CAMMENGA COMPANY, LLC
2011 BAILEY ST.
DEARBORN, MI 48124
Phone: 313.914.7160
Fax: 313.914.7153
www.cammenga.com

Response to RAI email received on 5/8/13. Control number 579632.

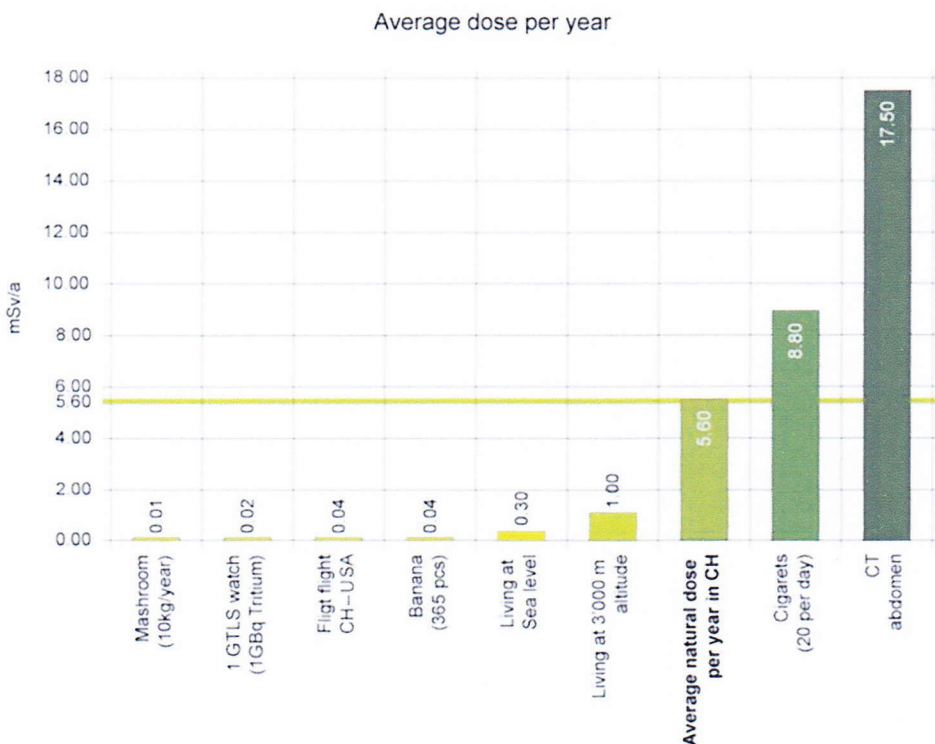
The *B.5. Section 32.22(a)(2)(vi), 10 CFR 32* requires information about external radiation levels at 5 and 25 centimeters from the external surface of the product. Cammenga uses Gaseous Tritium Light Sources (GTLS)s from MB Microtec in Switzerland. The Tritium in these sources is in gaseous form sealed in borosilicate glass tubes. The Tritium electrons do not exit this glass. The secondary radiation in question, “*Bremsstrahlung*” radiation is dependent on the energy of the primary radiator. In our case this is very low since we use Tritium. To calculate the dose [Sv Sievert] per hour [Sv / h, is the dose rate]. mSv / h or uSv / h is microsieverts per hour] of the radiation in the affected organ (or the whole body in this case) a certain time (which one is exposed to the source) are considered. Please see the below chart of average doses per year of common activities from MB Microtec (<http://www.mbmicrotec.com/en>). Compare our use of Tritium in this knife product (7.4 GBq) to the 1 GBq found in a Tritium watch in the chart:

This *bremstrahlung* effect cannot be measured with a Geiger counter but may be measured with a special ionization chamber monitor for Tritium in the form of gas or a liquid scintillator for contamination. This is confirmed in NUREG-1717 on page A.4-10, Table A.4.2 footnote b, which states the ^3H “Dose due to *bremstrahlung* is assumed to be zero (0), because the energies of the *bremstrahlung* photons are very low and pathways of internal exposure also are assumed to occur.”

For further analysis please review NUREG 1717 section 2.13.4.1.3 where the following was taken, “In estimating external dose from routine use of quantities of byproduct material authorized for exempt distribution...External dose is not estimated for radionuclides that emit photons with energies predominantly less than about 0.1 MeV, because the specific gamma-ray dose constant in these cases would substantially overestimate the EDE [Effective Dose Equivalent], especially if any shielding exists between the source and receptor locations. Furthermore, the primary purpose of this part of the assessment is to estimate external dose for those radionuclides for which the quantity was based on the criterion for external exposure, and this is the case only for radionuclides that emit sufficient intensities of higher energy photons.”

Through the analysis of MB Microtec and NUREG 1717 along with our own internal measurements, we have determined there are no (zero) external radiation levels at 5 and 25 centimeter distances from any external surface of our products.
